21555 Non-Transparent PCI-to-PCI Bridge

Datasheet

21555 Non-Transparent PCI-to-PCI Bridge

Specification Update

Figure 6. 304 PBGA (Four-Layer) Package

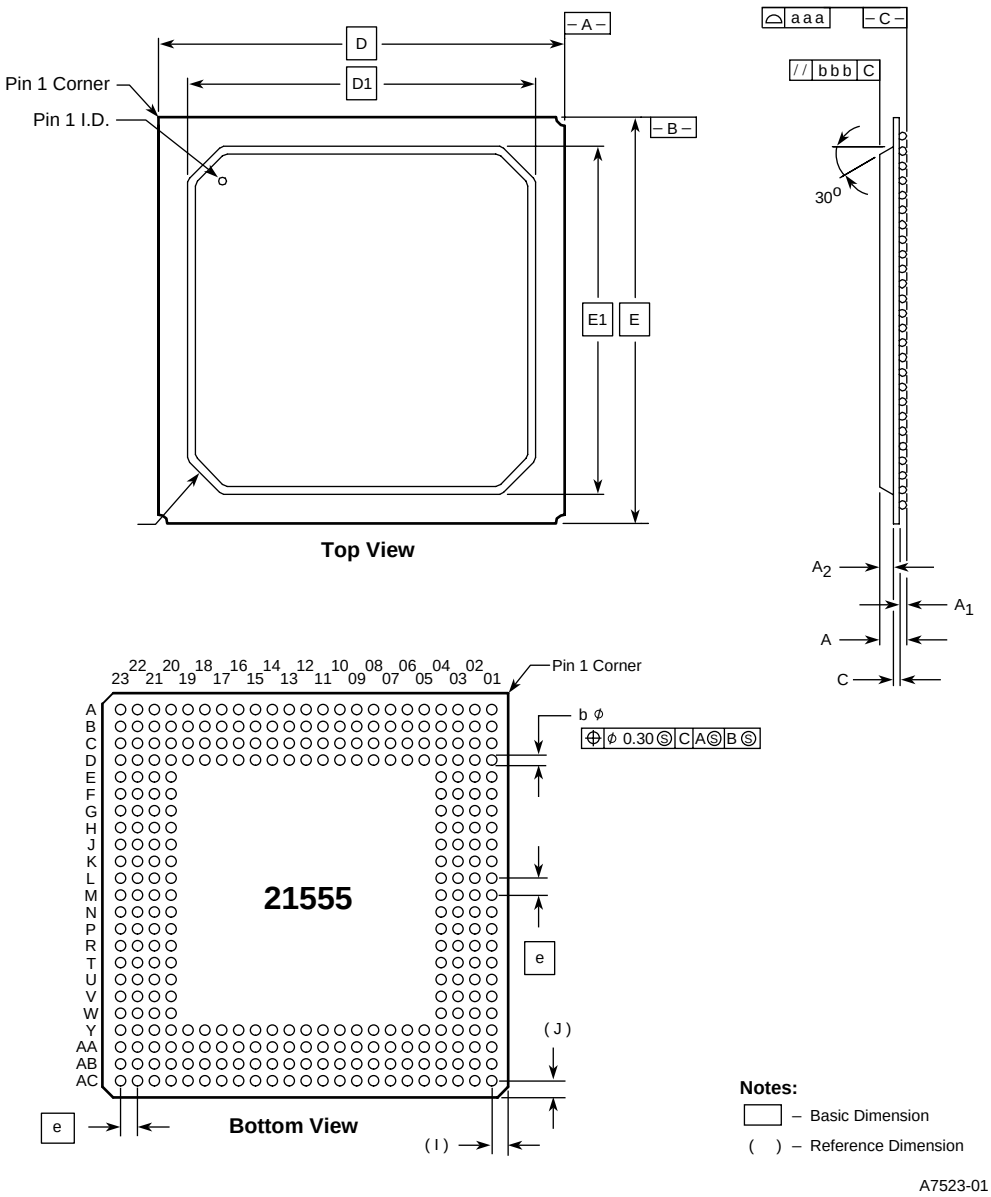
1. PBGA Package Dimensions for coplanarity changed from maximum value 0.15 mm to maximum value 0.2 mm.

Per PCN notification 961, the 304-point 4-layer PBGA package dimensions for symbol aaa, coplanarity, are changed from maximum value 0.15 mm to maximum value 0.2 mm.

Issue: The maximum value for symbol aaa, dimension coplanarity, has been changed from 0.15 mm to a value of 0.2 mm.

Figure 1. Node Boundary

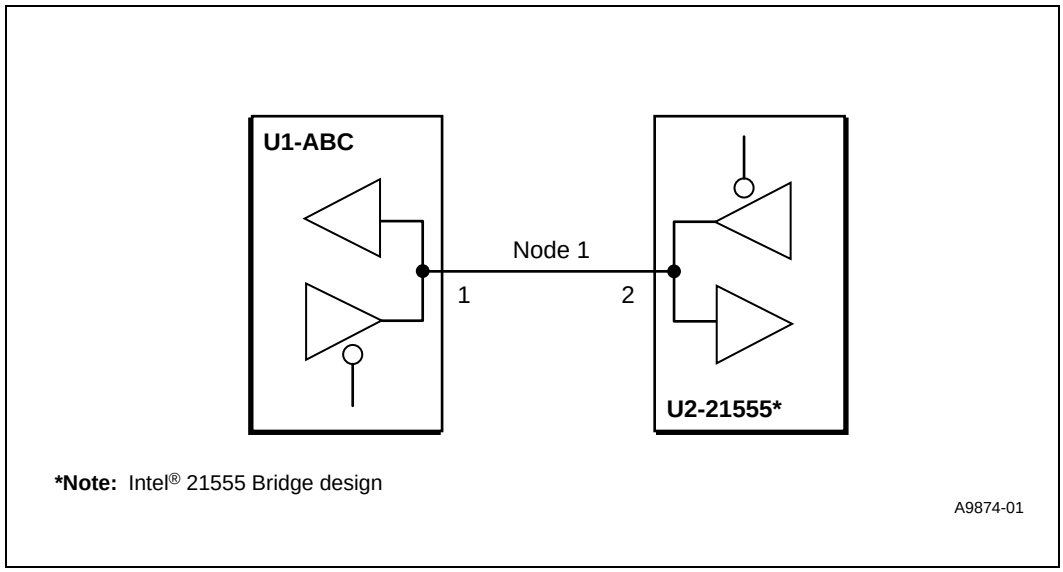
Workaround 2: Standalone boundary scan testers and In-Circuit testers performing chained boundary scan tests, should understand that the Parallel Output UPDATE data, being delayed by one clock, may cause bus contention and back driving during that one clock period, assuming the vectors change bus driving sources in one vector. This is because in chained boundary scan tests, all components execute TAP instructions in Parallel (or lock step), and vector generation algorithms optimize the number of vectors.

To understand the potential issue in detail, refer to the diagram below. Node 1 is a bi-directional node, with U1.1 and U2.2 connected as shown. Assuming that U1 is an IEEE1149.1 compliant device, that U2 is the 21555, and that the control cells of the 21555 were set during the vectors to enable the driver of U2.2 to drive to U1.1 (receiver). When switching drivers from U2 to U1, U2 should tri-state its driver prior to, or at the same time as, U1 enables its driver. Since the 21555 UPDATES its Parallel Outputs one clock late and the control cells which enable U2's drivers are Parallel Outputs which again updates one clock cycle late then U2.2, which will be driving at the same time U1.1 is driving. This contention will happen for one TCK cycle, until U2 UPDATES its parallel outputs. The period of this contention is dependent on the TCK frequency rate.

A remedy to the 21555's late UPDATE is to ensure the chained Boundary Scan tester's vectors do not switch bus driver directions in one vector. This means that one vector should disable U2's driver, and the next vector should enable U1's driver. ATPG vectors typically are not manually manageable in this way and this requirement may force an engineer's manual intervention. No single stepping of test clock through the TAP State Machine should be allowed with the 21555 in the boundary scan chain. The resulting contention would increase the potential back drive time, increasing the possibility of device damage.

Status: Fixed.This behavior has been corrected in the 21555AB/BB Step A3 device.

Figure 12-1. Signal trst_l States

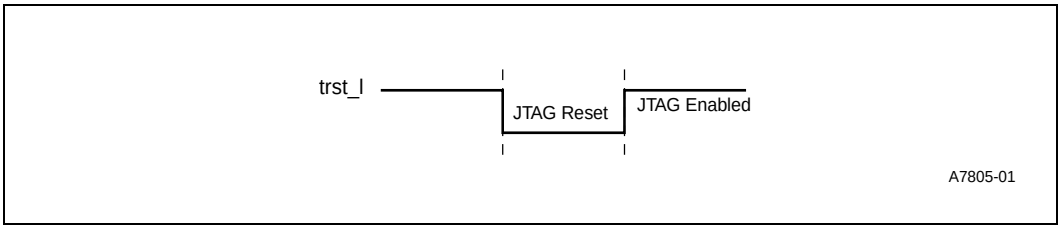
13. Change to Initialization Section 12.2.1 and JTAG Description

Issue: Change to second paragraph. Also made a change to normal operation description note for JTAG below Figure 12-1. The section now appears as follows:

The test access port controller and the instruction register output latches are initialized and JTAG is disabled while the **trst_l** input is asserted low (see Figure 12-1). While signal **trst_l** is low, the test access port controller enters the test-logic reset state. This results in the instruction register being reset which holds the bypass register instruction. During test-logic reset state, all JTAG test logic is disabled, and the device performs normal functions. The test access port controller leaves this state only after **trst_l** (low) goes high and an appropriate JTAG test operation sequence is sent on the tms and tck pins.

- Asynchronously with the assertion of **trst_l** .
- Synchronously after five **tck** clock cycles, with **tms** held high.

Note: Prior to normal 21555 operation, this signal must be strobed low or pulled low with a 1kΩ resistor.
